INITIAL FIRE SAFETY INSPECTION REPORT

Santic (Bangladesh) Co. Ltd.

RSC ID: 26154

Date: 27-February-2025

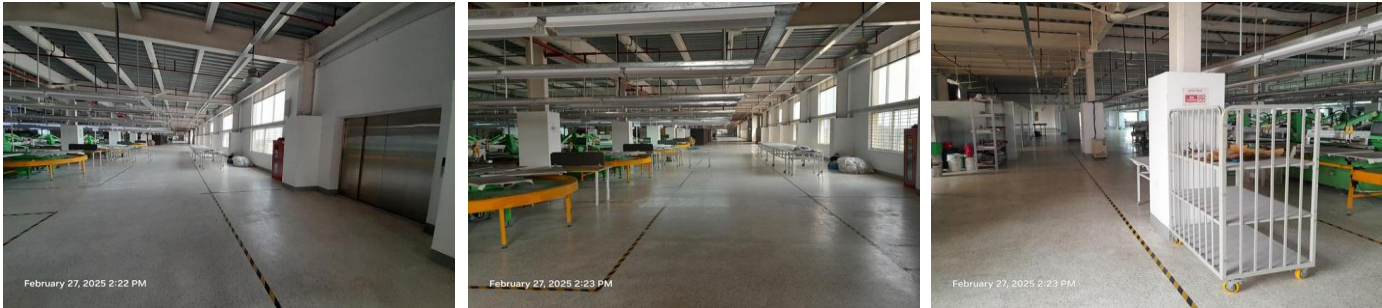
F-03	Fire Rated Construction	Building-01: Unsealed penetrations and openings are located in the fire rated floor/ceiling assemblies (plumbing pipe penetration in toilet blocks, electrical cable risers, sprinkler drain lines, etc.) on all floors.	Seal all penetrations and openings in floor/ceiling assemblies to maintain the fire separation at least by 3-hr. The used sealer shall be 3rd party certified and installation shall be as per manufacturer's guideline. or, Provide a minimum 2-hr fire rated shaft to separate the utility risers from each floor if required. or, Provide a minimum 2-hr fire rated shaft to separate the utility risers from each floor level or seal all penetrations and openings in floors/ceiling assemblies by 3-hr fire rated listed/certified materials. The installation of such fire rated materials shall be following certified design.	Within 3 months

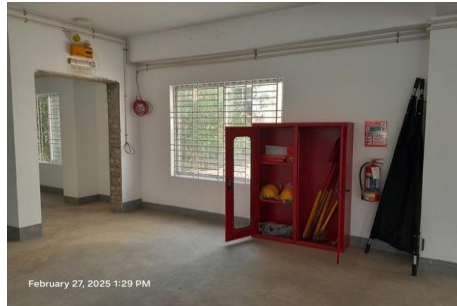
F-11	Means of Egress	Building-01: Aisles marks were found missing at several locations on the production floor. Location: On 2nd & 1st floor.	Aisles shall be provided with a minimum unobstructed clear-width of 0.9 m (36 in.).	Within 1 month
